Independent Monitor ENVIRONMENTAL PERFORMANCE ANNUAL REPORT 2015

McARTHUR RIVER MINE

AUGUST 2016
Report No. 01164C_1_v2

**Independent Monitor
Environmental Performance Annual Report
2015**

FIGURE 4.7

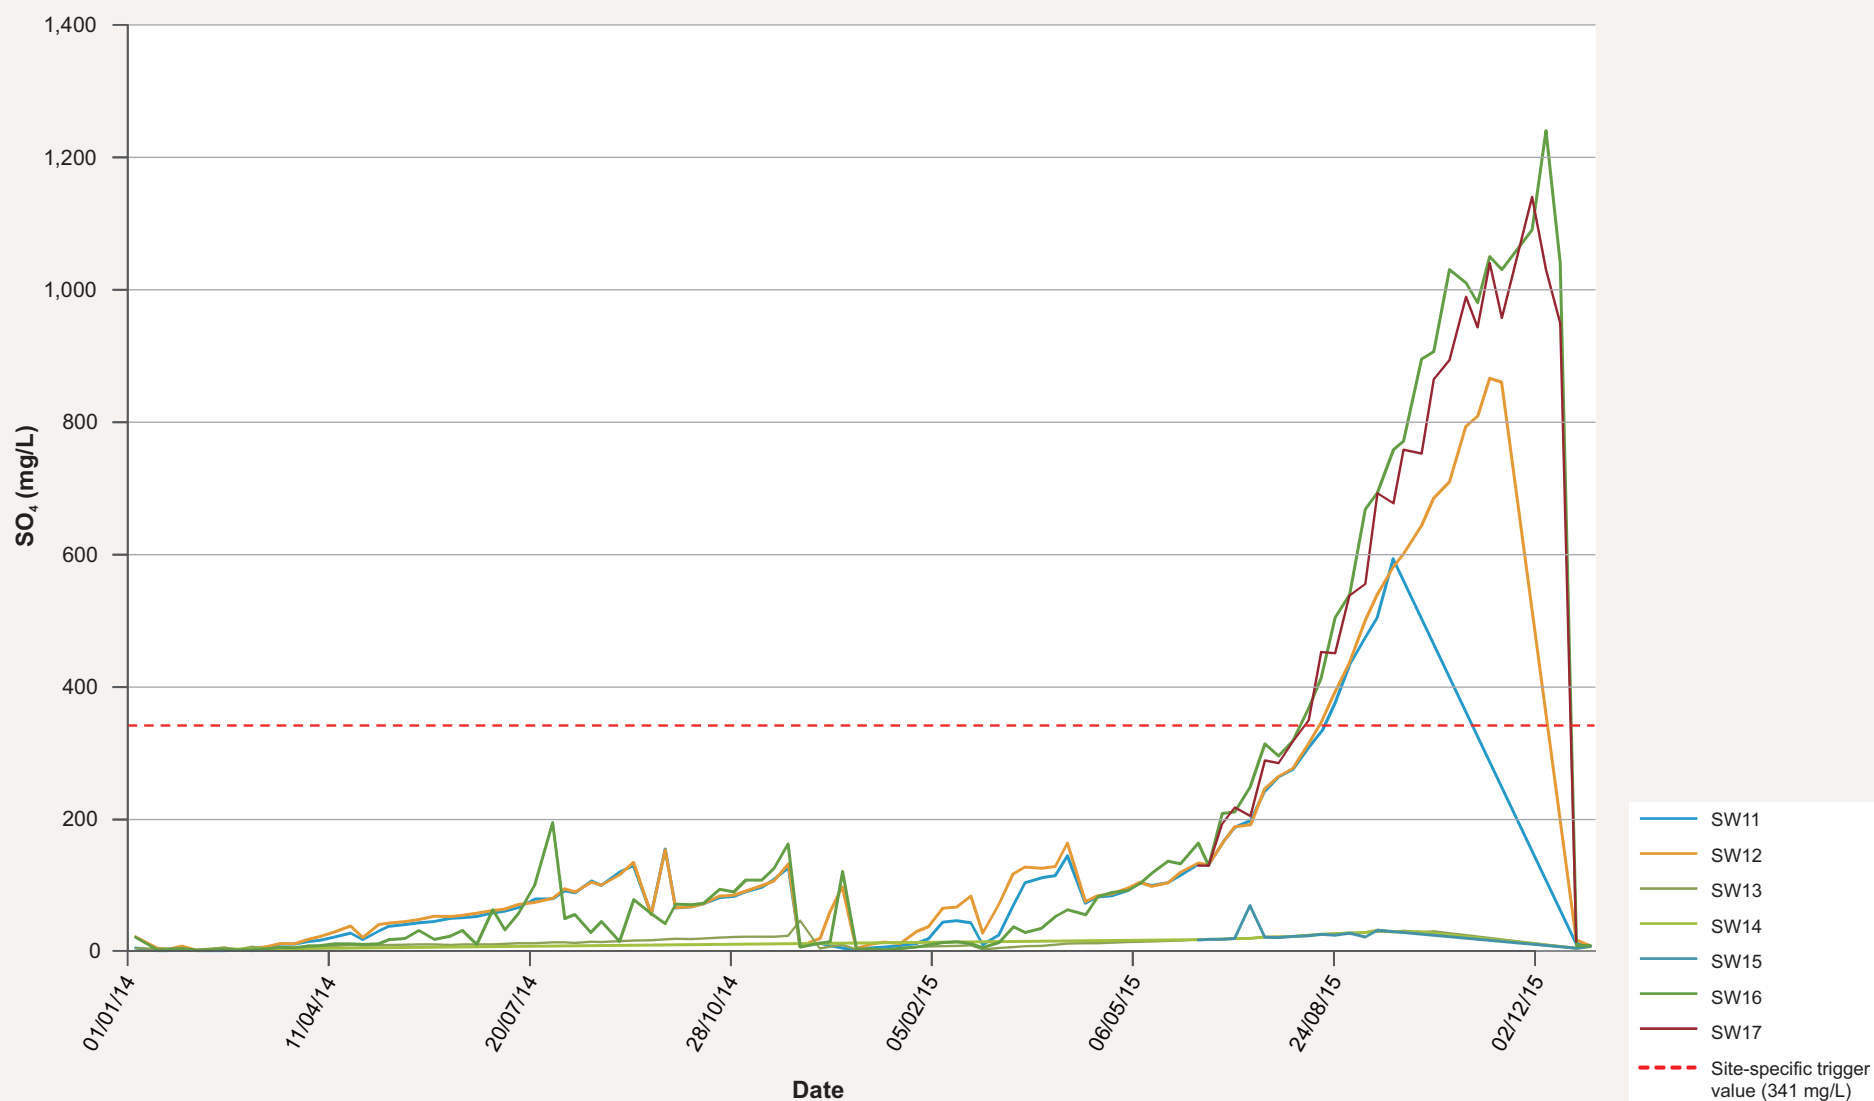
Elevated EC related to SO_4 was observed in the McArthur River diversion channel in the 2015 dry season from monitoring point SW16 downstream through SW17, appearing to influence EC at SW11 (MRM, 2015e). Figure 4.7 (Section 4.3) shows SO_4 concentrations along McArthur River, with monitoring points ordered from upstream to downstream. Site SW15 is upstream of SW16, and showed SO_4 concentrations of less than 50 mg/L, compared to elevated SO_4 levels at SW16

and SW17 peaking at over 1,000 mg/L. These results clearly indicate a SO₄ source between SW15 and SW16. Geological inspection identified zones of mineralisation along the diversion, which MRM believes may be the source. However, the ELS is reasonably close to SW16 and could also be a potential source. The planned groundwater assessment of the ELS will address this aspect (MRM, 2015i). Figure 4.7 (Section 4.3) shows the location of two groundwater monitoring bores, GW129 and GW136, between the ELS and McArthur River diversion channel that have elevated EC, corresponding to SO₄ of over 2,000 mg/L, again possibly indicating seepage from the ELS into the diversion channel. Whatever the primary source of salinity in the McArthur River diversion channel, the presence of exposed sulfidic rock in the excavated banks will require management to prevent local impacts on water quality and revegetation success. The IM understands that MRM plans to clay line the ELS to control seepage.

FIGURE 4.18

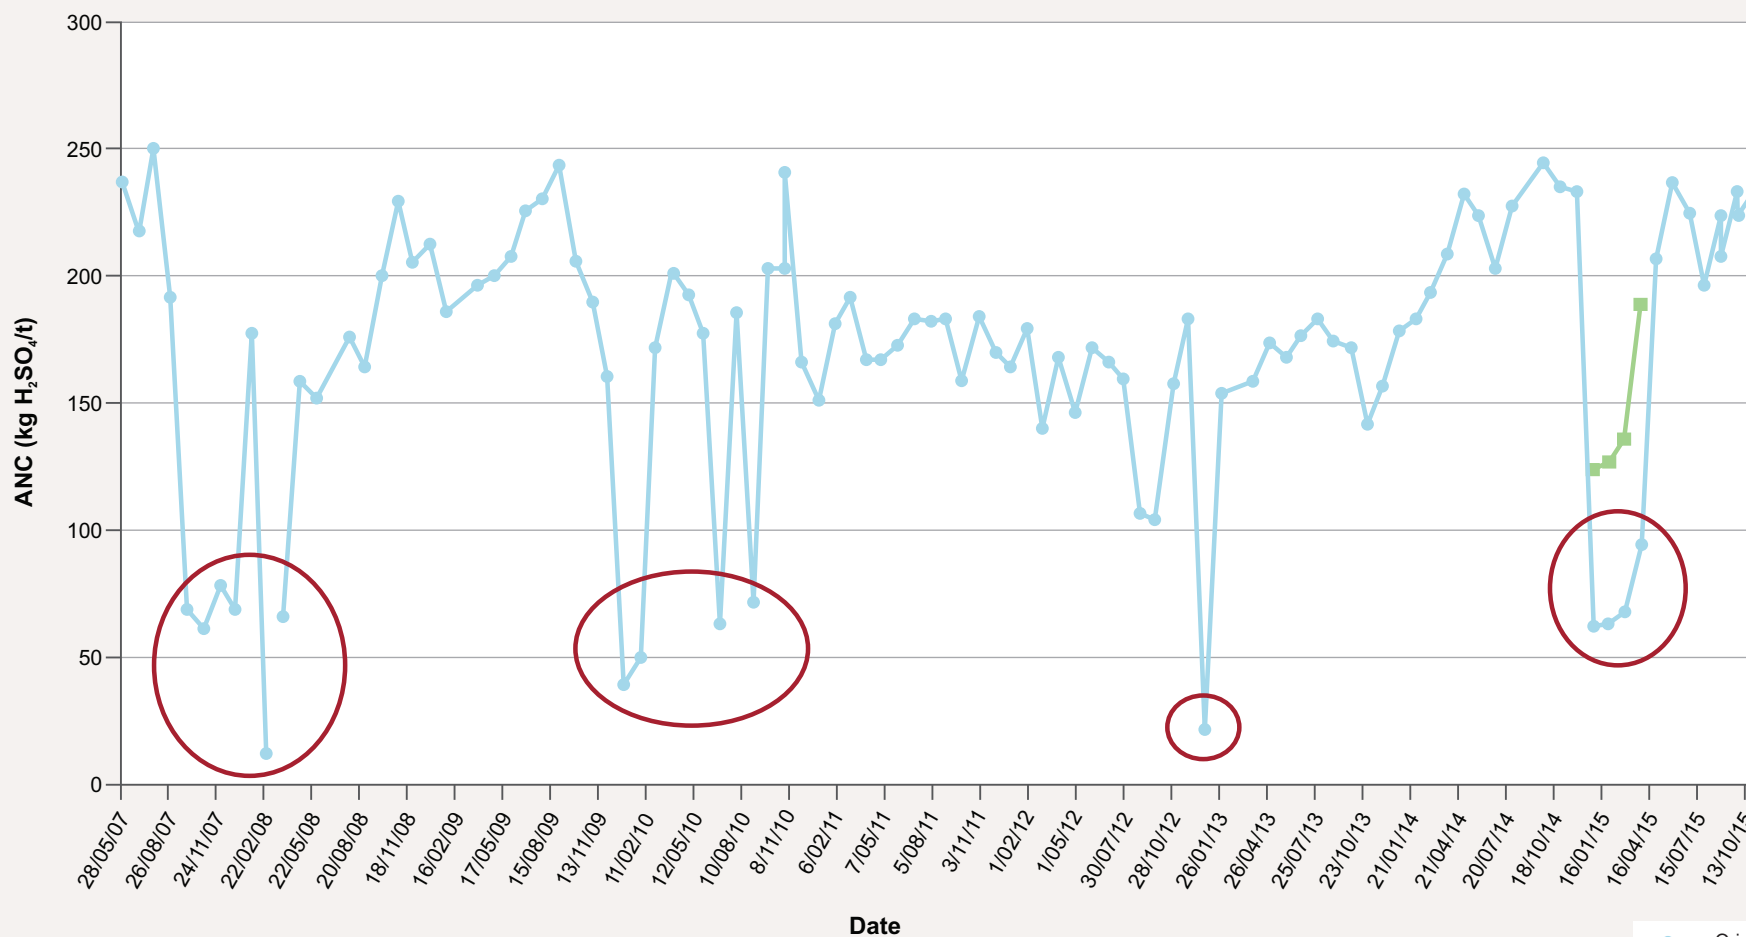
are anomalous, with the vast bulk of the tailings samples having ANC values greater than 150 kg H₂SO₄/t. Repeat testing of these samples (see Figure 4.18) showed a definite decrease in ANC relative to other samples, but the ANC values were significantly higher than the original test results at greater than 100 kg H₂SO₄/t. McArthur River Mining personnel indicated that these anomalous results were from samples that were tested by a different laboratory to that used for most of the other samples, and that the original results may have been in error. The IM recommends that the ANC results be checked with ANC testing carried out at other laboratories and include ABCC testing to be certain which set of results best reflects the available ANC in the tailings. Results from ABCC testing carried out on the five samples collected from the Cell 2 margins (KCB, 2015c) indicate that the effective ANC was around 60 to 70% of the total ANC.

Plate 4.6 –TSF Cell 2 Surface in More Detail

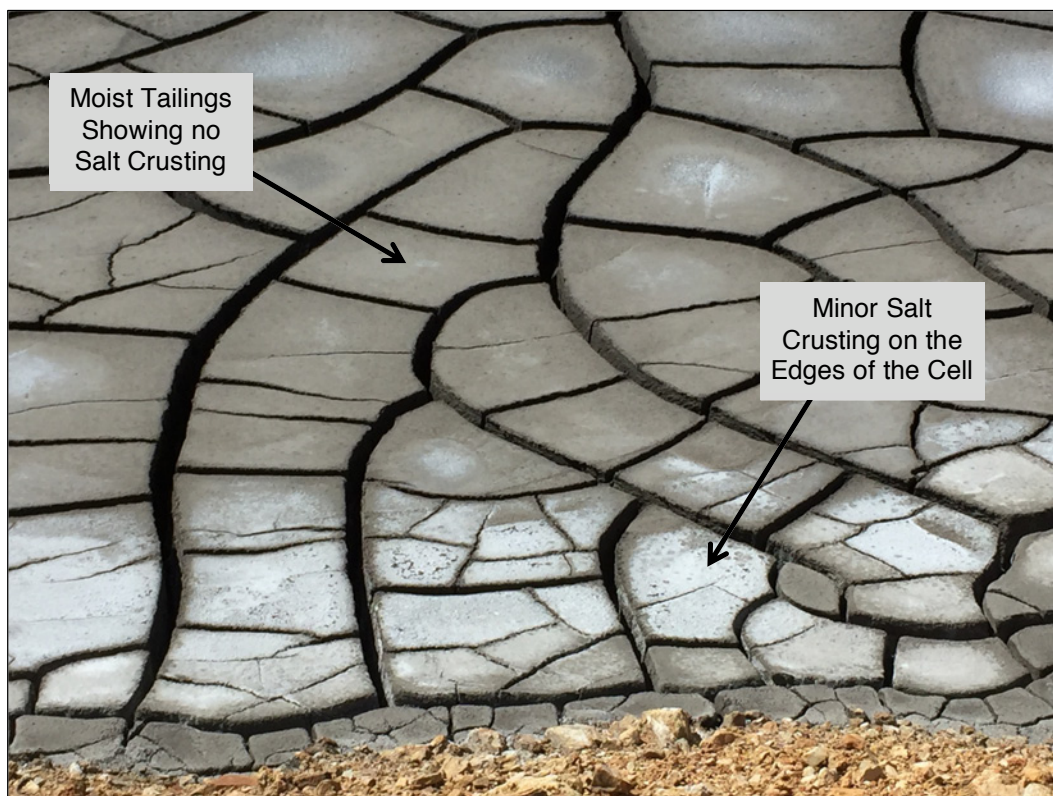
The current tailings and water management approach at Cell 2 will reduce seepage into groundwater, but it may take some time before this is evident in groundwater monitoring bores. The recent low rainfall wet season has obviously assisted in minimising water stored in the TSF and consequent seepage. Maintaining low seepage from the TSF may be more of a challenge in a high rainfall wet season.
